**UNITED STATES OF AMERICA  
BEFORE THE  
FEDERAL ENERGY REGULATORY COMMISSION**

PJM Interconnection, L.L.C. )  
 ) Docket No. ER17-1567-000  
 )

**COMMENTS OF THE INDEPENDENT MARKET MONITOR FOR PJM**

Pursuant to Rule 211 of the Commission's Rules and Regulations,<sup>1</sup> Monitoring Analytics, LLC, acting in its capacity as the Independent Market Monitor for PJM<sup>2</sup> ("Market Monitor"), submits these comments responding to the Order No. 831 compliance filing submitted May 8, 2017, in this proceeding by PJM Interconnection, L.L.C. ("PJM") ("May 8<sup>th</sup> Filing").

Figure 1 FERC northeast natural gas trading hub map<sup>7</sup>

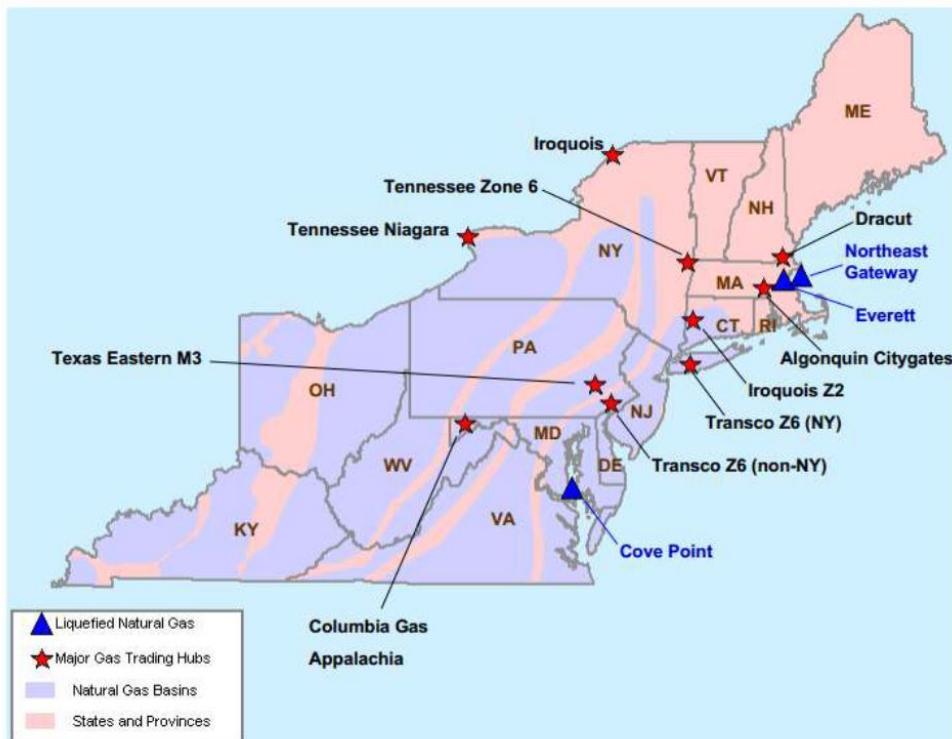
PJM proposes to use “a geographically appropriate commodity trading hub” to determine the fuel cost for gas fired generators. Multiple interstate natural gas pipeline systems serve the PJM region, often in close geographic proximity. Many natural gas fired generators have access to multiple natural gas trading hubs. Figure 1 presents a map of some of the natural gas trading hubs in the PJM region. It shows, for example, the close proximity of the Texas Eastern M3 trading hub to the Transco Z6 (non-NY) trading hub. Further south, generators also have access to Columbia Gas, Dominion (DTI) and two Transco zones (Z6 non-NY South and Z5) trading areas. There are also multiple trading hubs in close proximity in the Chicago area. Some generators have consistent access to the lowest price of multiple hubs. Other generators face conditions where the market price at the generating unit’s location consistently converges on the highest price of multiple hubs. The determination of the appropriate trading hub varies with economic conditions in the gas market, physical interconnections, and the business practices of the generator. Geography is not sufficient to determine the appropriate trading hub. It is not appropriate for PJM to substitute its vague and undefined “geographically appropriate” criterion for the results of the Market Monitor’s thorough fuel cost policy review process, which covers at least 89 percent of all gas-fired units.

During the Fuel Cost Policy review process, the Market Monitor carefully reviews and discusses in detail with market participants all scenarios to ensure that the Fuel Cost Policy accurately represents the market conditions facing each generator. The determination of the accurate trading hub under the defined scenarios in the Fuel Cost Policy is the best source of information available to PJM and the Market Monitor. The use of a trading hub different than those defined in the Fuel Cost Policy would mean substituting PJM's judgment, based on no stated criteria, for the clearly defined, reviewed and agreed upon Fuel Cost Policy. The result would be an incorrect fuel price, an incorrect offer and

incorrect energy market clearing prices. To illustrate the significance of this point, Table 1 includes several natural gas trading hubs used by generators in each PJM zone and the largest difference, converted to incremental energy costs in dollars per MWh, between any two of those index prices on January 22, 2014, when natural gas prices exceeded levels that would result in incremental costs greater than \$1,000 per MWh.<sup>8</sup>

These examples show the extreme range of natural gas prices in small geographic areas. Divergence of over 100 percent is common when winter temperatures fall below freezing. If PJM makes simplistic, static assignments of generators to single, “geographically appropriate” trading hubs, it will grossly underestimate the cost of gas in some cases and grossly overstate the cost of gas in other cases. The Commission should require use of the

most accurate information available, the Fuel Cost Policy, for estimation of fuel prices for each generator using trading hubs.
